UNITED STATES PATENT AND TRADEMARK OFFICE

APPLICATION NO.	FILING DATE	FIRST NAMED INVENTOR	ATTORNEY DOCKET NO.	CONFIRMATION NO.
10/524,861	02/15/2005	Bernard Bouffier	BDL-67	3004
20311	7590	06/30/2006		
LUCAS & MERCANTI, LLP 475 PARK AVENUE SOUTH 15TH FLOOR NEW YORK, NY 10016			EXAMINER HOPKINS, CHRISTINE D	
			ART UNIT	PAPER NUMBER
			3735

Office Action Summary

DETAILED ACTION

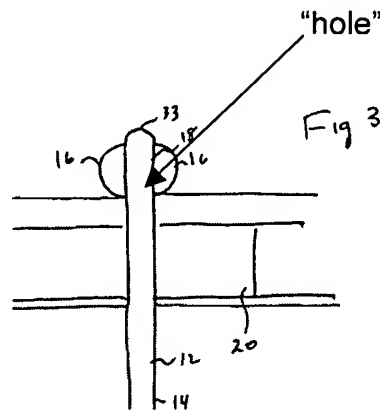
In reference to claim 19, the anchoring device of Skiba is constructed from a biocompatible polymer, or "flexible and deformable material" (col. 7, lines 15-19) and comprises "lateral arms" (element 16) as portrayed in Fig. 2b. Furthermore, in view of claim 20, the "lateral bridging arms" of Skida may form a "kink" (as depicted in the transition from Fig. 2a to 2b) after insertion into the tissue region (element 20).

With respect to claim 21, the connector or "sliding component" (element 14) of the anchoring device of Skiba is configured to be subject to considerable pulling forces resulting from the draw on the bladder by the "elongated support component" or suspending device, element 50 (col. 8, lines 1-13).

The anchoring device of Skiba forms a "cage" and contains at its upper end a "tubular component" (element 18 of Fig. 2b) and forms a region for the "sliding component," or connector, which is configured with holes for pulling the traction component (col. 8, lines 1-8). Furthermore, with respect to claim 26, the opposing end
